Docket Item # 7
BAR CASE # 2009-0043

BAR Meeting
May 6, 2009

ISSUE: After-the-fact Alterations

LOCATION: 113 King Street

Figure 1 Photograph of the front facade of 113 King Street depicting the 6 replacement windows.

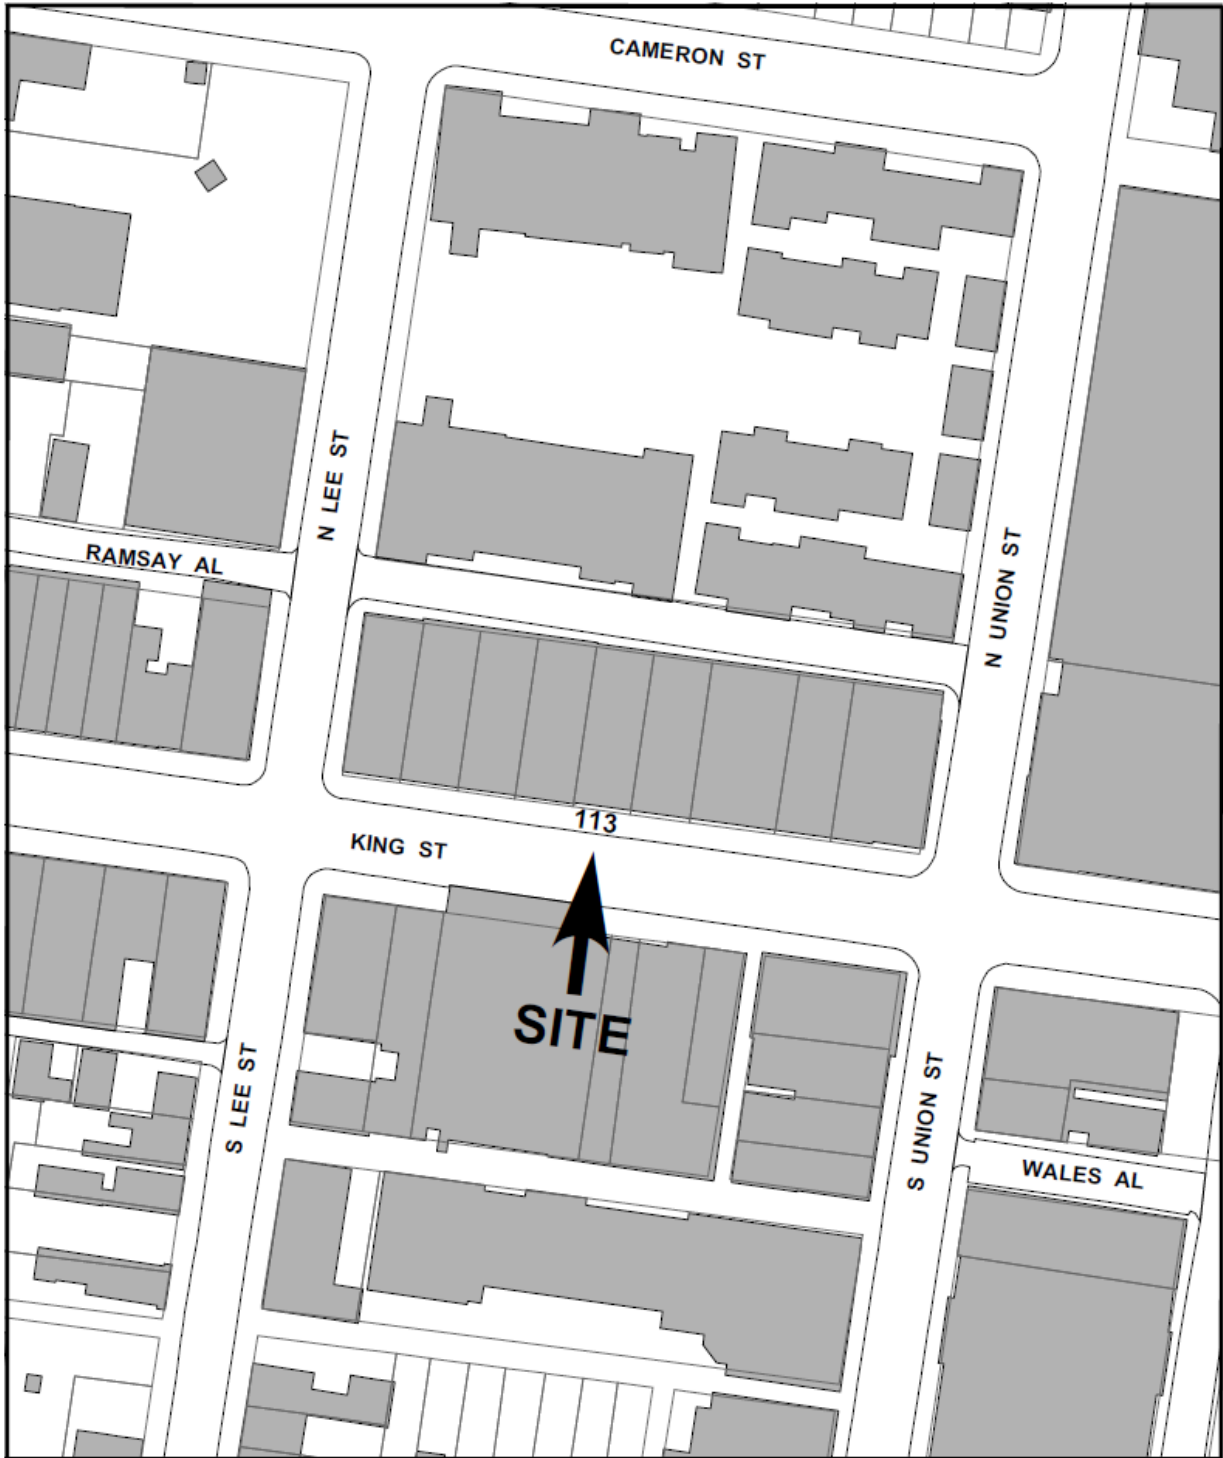
The applicant is requesting after-the-fact approval of a Certificate of Appropriateness for replacement windows on the second and third floors of 113 King Street. All of the second and third floor windows on the front façade facing King Street were removed, discarded, and replaced without BAR or Staff approval and replaced with MW Jefferson cellular PVC, double hung, Simulated Divided Light windows. Due to the fact that the replacement of the windows came to the attention of City Staff after the existing windows had already been removed there is no way to definitively determine either the age or type of window that was removed. City Staff notified Mr. Lotto of the violation in a letter dated February 11, 2009 indicating that he would need to apply to the Old and Historic Alexandria Board of Architectural Review for after-the-fact approval for window replacement.

Due to the highly visible location of the replacement windows and the desire to retain the historic integrity of the building, Staff finds the use of cellular PVC, Simulated Divided Lite windows to be highly inappropriate. Therefore Staff recommends that the applicant be allowed to replace the six windows on the second and third story of the front façade with appropriate all wood, single glaze, true-divided light double-hung replacement windows that exactly mimic the glazing pattern of the original windows that were removed, with specification sheets to be submitted and approved by Staff prior to purchase and installation.

R- Deny

1. That the applicant pay a \$600 fine per Article 10 and 11-207 of the zoning ordinance.
2. That the applicant be allowed to replace the six windows on the second and third story of the front façade with appropriate all wood, single glaze, true-divided light double-hung replacement windows that exactly mimic the glazing pattern of the original windows that were removed, with specification sheets to be submitted and approved by Staff prior to purchase and installation.

S- Replace with wood window sash with full divided lights replicating original.
